**RE: SSI 9775 - NEW MAITLAND HOSPITAL (STAGE 2)  
METFORD ROAD, METFORD (LOT 7314 DP 1162607 AND PART LOT 401  
DP 755237)**

I refer to your letter dated 8 July 2019, inviting Council to comment on the State Significant Infrastructure (SSI) application for the development of the New Maitland Hospital (Stage 2 - Detailed Design and Construction), located at Metford Road, Metford and advise that Council wishes to make the following comments in relation to the SSI proposal:

### *Access grades*

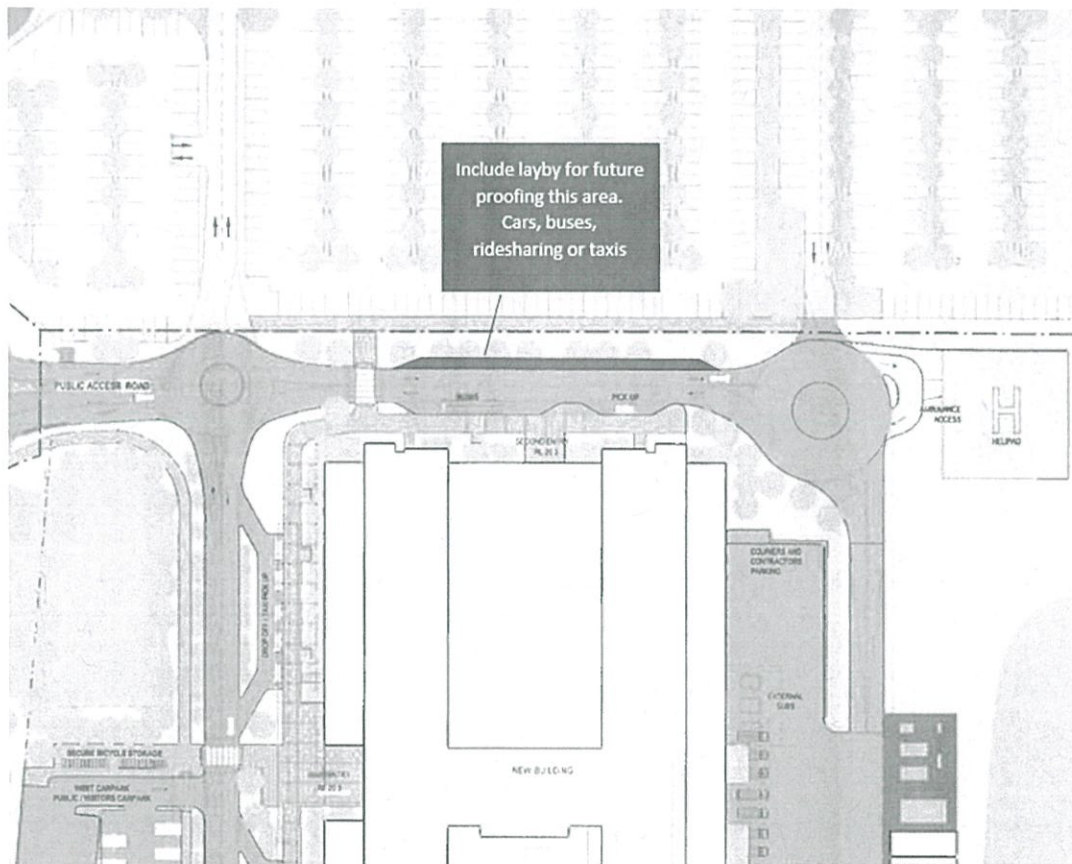
All internal paths from the hospital building to transport facilities should have accessible grades.
